## PIC18CXX2 Rev. B Silicon/Data Sheet Errata

The PIC18CXX2 (Rev. B) parts you have received conform functionally to the Device Data Sheet (DS39026C), except for the anomalies described below.

## Clarifications/Corrections to the Data Sheet:

**FIGURE 21-3: PIC18CXX2 VOLTAGE-FREQUENCY GRAPH (EXTENDED)**

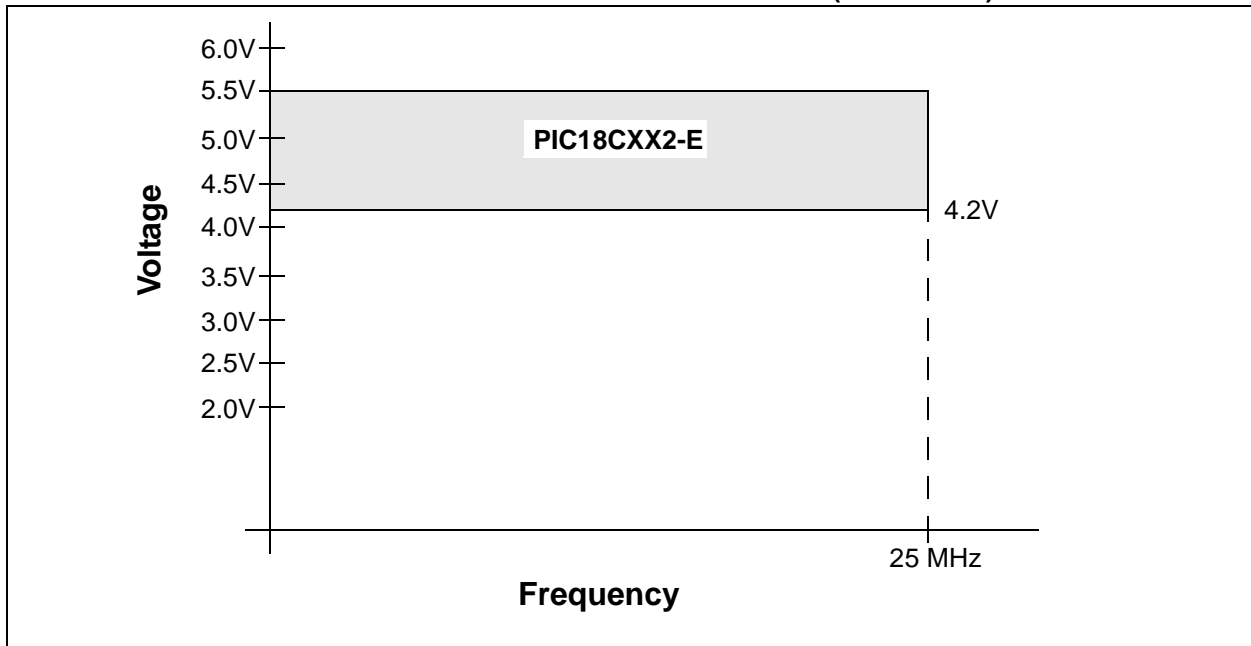
The operating frequency range for extended temperature devices has been changed.

The maximum external clock frequency (EC and ECIO modes) and oscillator frequency (HS mode) for extended temperature devices has been changed to 25 MHz. When the PLL is used

(HS+PLL mode), the maximum clock and oscillator frequency has been changed to 6.25 MHz. Other values of related parameters have changed accordingly.

Figure 21-3 (below), reflecting the voltage-frequency performance of extended temperature devices, is added to the Device Data Sheet:

### FIGURE 1: INTERRUPT LOGIC (EXCERPT)

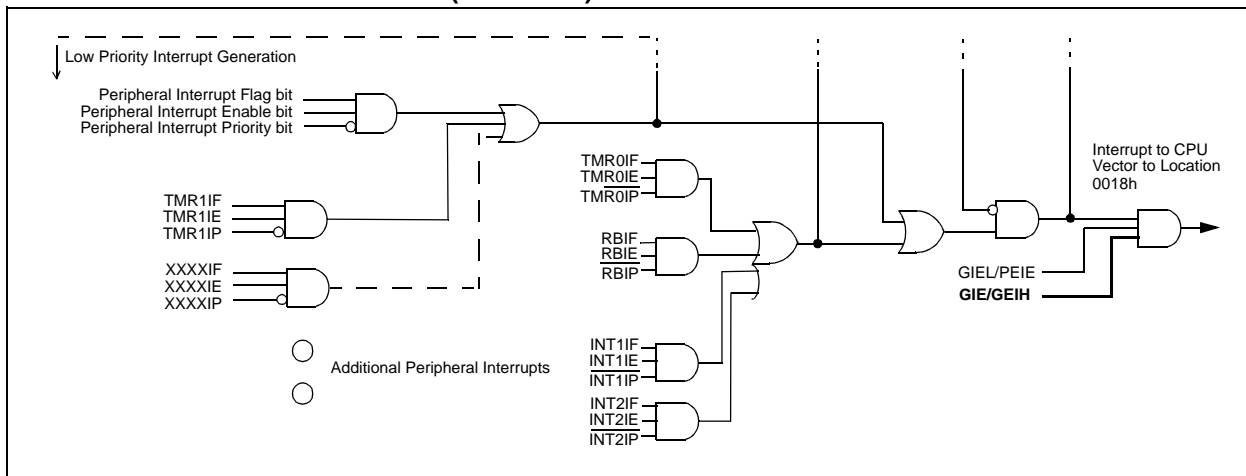
The operation of the GIE/GIEH bit (INTCON<7>) is clarified as follows: when the bit is cleared, all interrupts are disabled. This is regardless of the state of the IPEN bit (RCON<7>), the priority of the interrupt, or whether or not the interrupt is unmasked. This varies from the original description, in which clearing the bit when IPEN = '1' would only disable high priority interrupts.

Also, the interrupt logic funnel shown in Figure 7-1 of the Device Data Sheet is amended with the addition of a GIE/GIEH control line, as shown in Figure 1 (new material in **bold line**).
